BRE Client Report

Chalcots Estates, Camden

Prepared for: Astrid Kjellberg-Obst
Date: 8th June 2020
Report Number: P116025-1000 Issue: 6

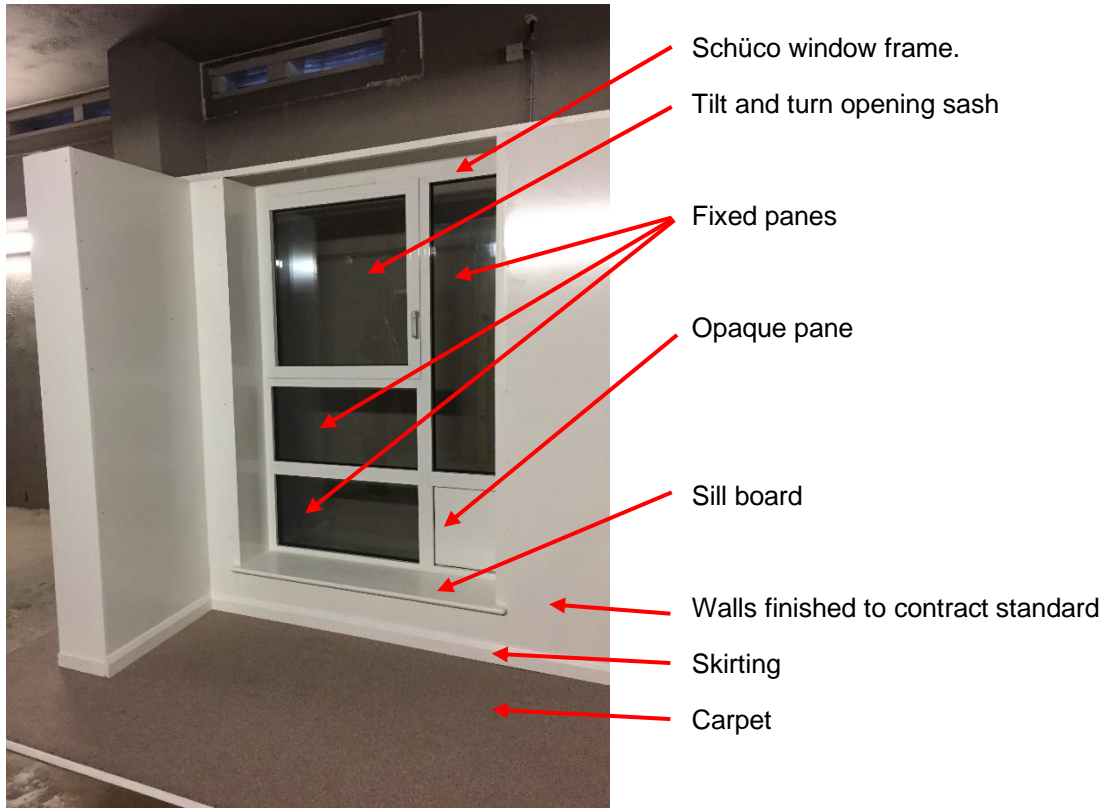
- I.12 Although empty at the time of the inspection, Wates confirmed that the residual cavity underneath the new window board was to be filled with insulation for the purposes of minimising heat loss.

- I.13 The cavity was seen to have been fitted with a fire stop material at floor level, representing the approach to be adopted as part of the overall solution, meaning that a compartment was to be created at floor level. Although not seen on the large living room window, Wates confirmed that fire stopping to the window frame perimeter, including jambs and head, would be installed in accordance with Building Regulations.

- I.14 The partially constructed sill board of the large window allowed examination of the fixing arrangements which appeared to show no accommodation for live load on the newly created bench seats. As components subject to sitting and most probably standing, there was no allowance for the sill board, plasterboard or metal framing sections to move differentially from each other.

[1583] Sample large window in the basement of Burnham block.

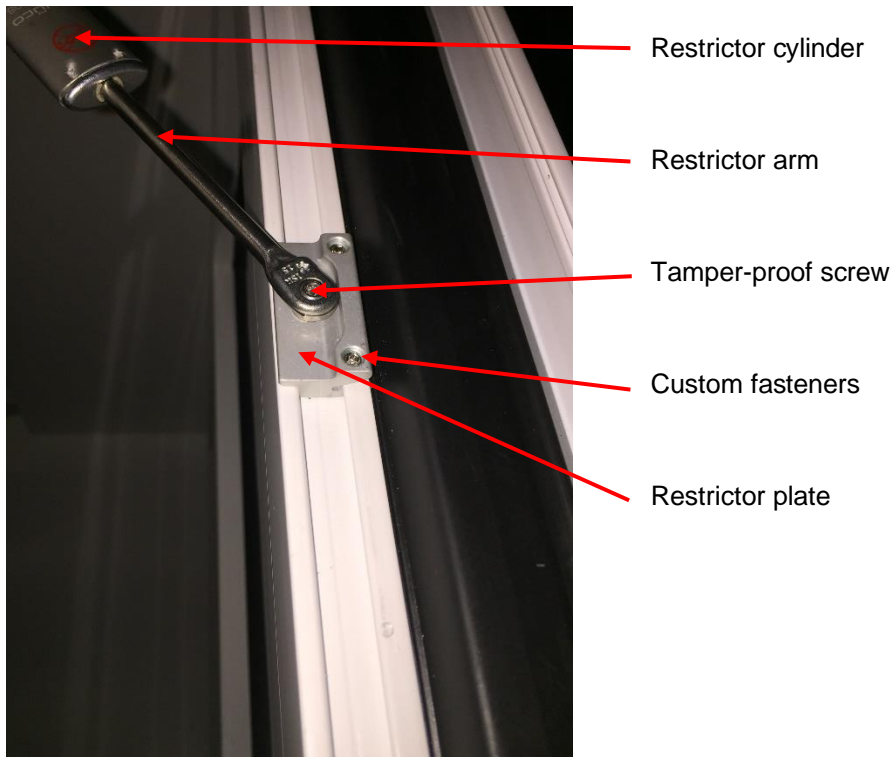
- I.20 The external face of the window system, whilst complete, was not set in an arrangement which replicated the external façade, lacking, among other things, cladding materials and membranes. Drainage caps were present and were seen to be correctly created when viewed via the opening sash.

- I.21 An opaque panel had been incorporated into one of the lower fixed panes as an example of obscurity, intended to help with occupants suffering vertigo. Camden explained (31st March 2020) that for planning reasons, this option will not proceed, but rather a film or other device will be used to provide comfort for those residents suffering from vertigo.
